# SERVICE BULLETIN

**BULLETIN NUMBER:** 259

**SUBJECT:** Drive Belt Tension

3.0 BPMG-612

## ADJUSTING THE DRIVE BELT

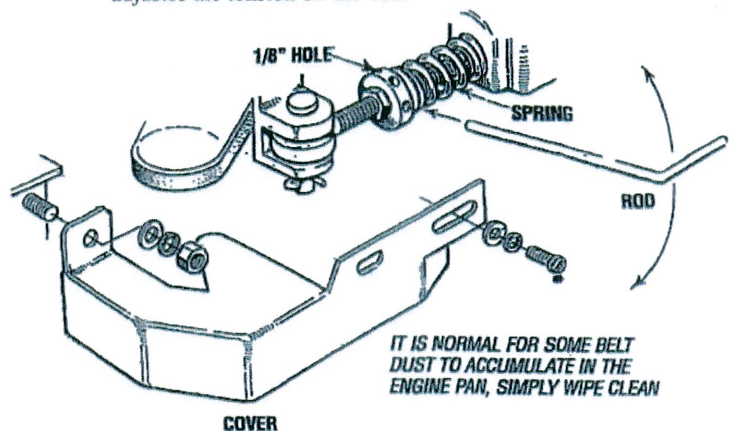
**DETAIL:** The generator drive belt tension specification as shown/illustrated in the Operator's Manual publication #048009 is in error. It does not coincide with our engineering design and the actual adjustment being set by our manufacturing department. The adjustment specification of 1-1/4 inches (31.79mm) should be 1-1/8 inches (28.57mm).

The illustration below reflects this specification correction.

To set the spring tension at 1 1/8", release the jam nut and use a rod such as an allen wrench to turn the adjusting nut (as shown) to tighten or loosen the spring tension, which in turn adjusts the tension on the belt.
